Twin Falls Planning & Zoning Commission Agenda

Wednesday, August 6, 2025, 12:00 PM

Consideration of an alternative plan and grouping to the required landscape per city code, Title 10-11-3 (A) 4, for the Canyon Trail Junction Chobani Wellness Park located at 2550 Pole Line Road East. (PZ25-0103)

Subject: 2250 Pole Line Rd E - Canyon Trail Junction Chobani Wellness Park with Restroom Plans - Zoning Review

SITE PLAN -
OVERALL

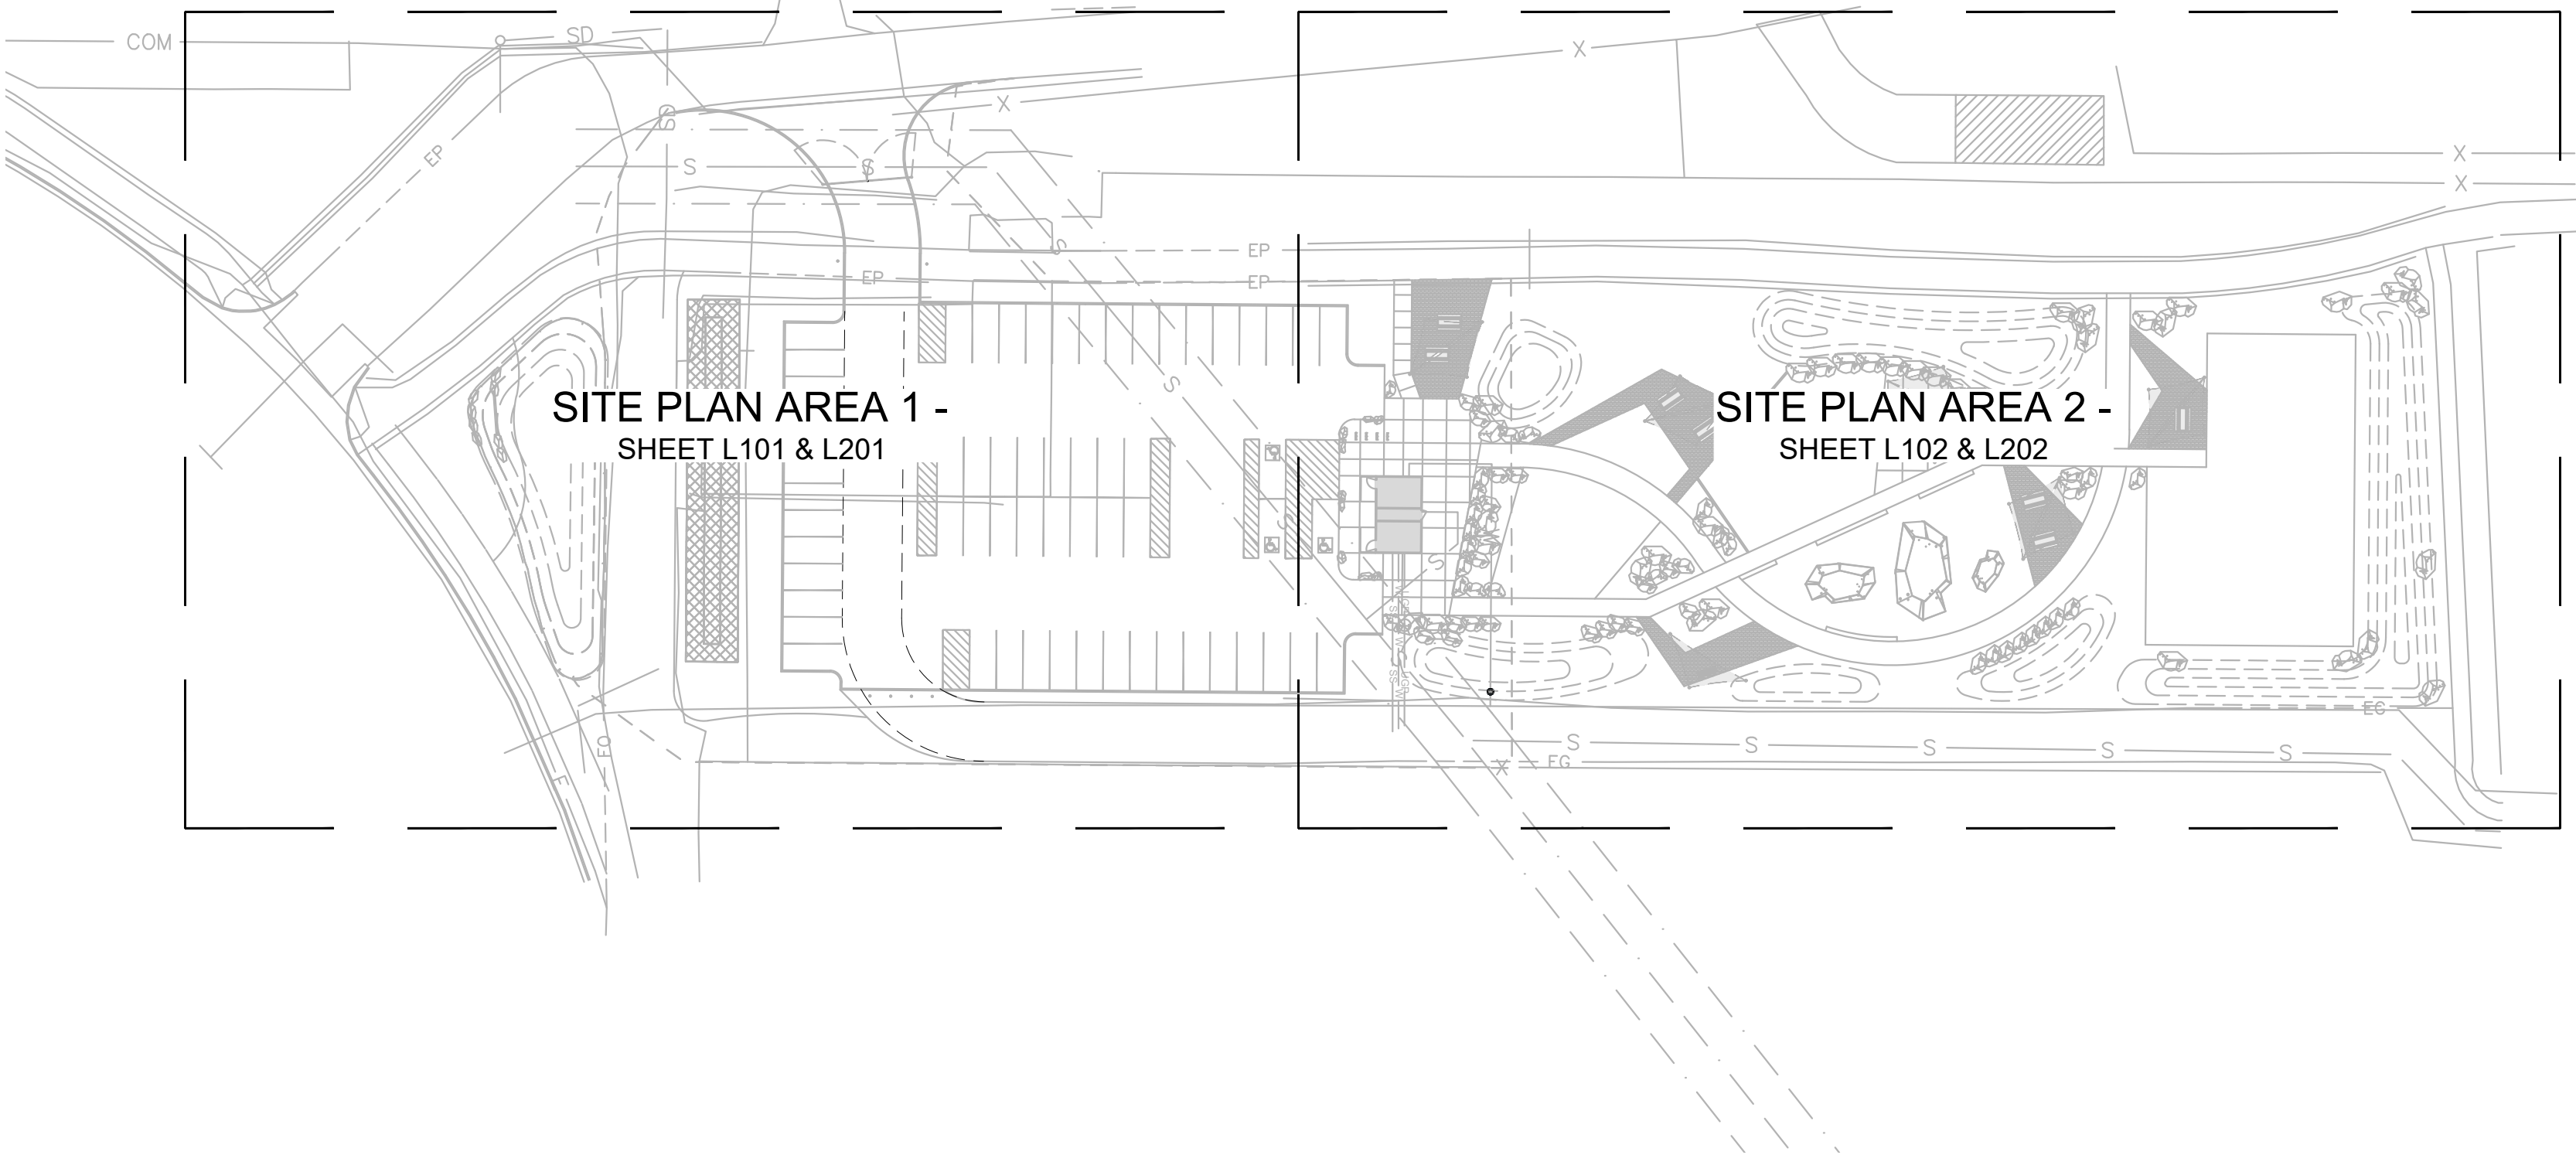
- Civil plans and landscaping parking plans don't match. Provide matching site plans for civil and landscaping so that we know which ones are the actual parking layouts. (Building comment)

- Landscaped parking islands required. Please revise plans to reflect this requirement. (This can be modified).
- 10-10-11: Interior Landscaping required in parking area that contains 20 or more parking spaces. 8'x15' Landscape islands shall be located at the terminus of all parking rows.
- Each island to be protected by a raised 6" curb and 1 tree required in each island.

- 1) We'll get an updated parking lot drawing from architect to match.
- 2) Parking Islands: we are installing a low-water use landscape and trying to limit plantings.
- 3) Same with note 2
- 4) Same with note 2
- 5) Lighting required unless it is locked at night, correct? We are proposing a gate, which will be locked up with our restroom closures at night.
- 6) Trash is picked up by parks staff each day with no large bin on-site.

- 7) Since PI water was not available on-site, we are proposing to use Potable. Because of this, we reduced plant quantity for water efficiency.
- 8) 35' landscape buffer is provided, but not all in trees and shrubs. A native plant mix is proposed in the berm with minimal trees and shrubs for water conservation
- 9) Park will be locked at night.

We can add a few more trees along Eastland if that helps meet the intention of that corridor.
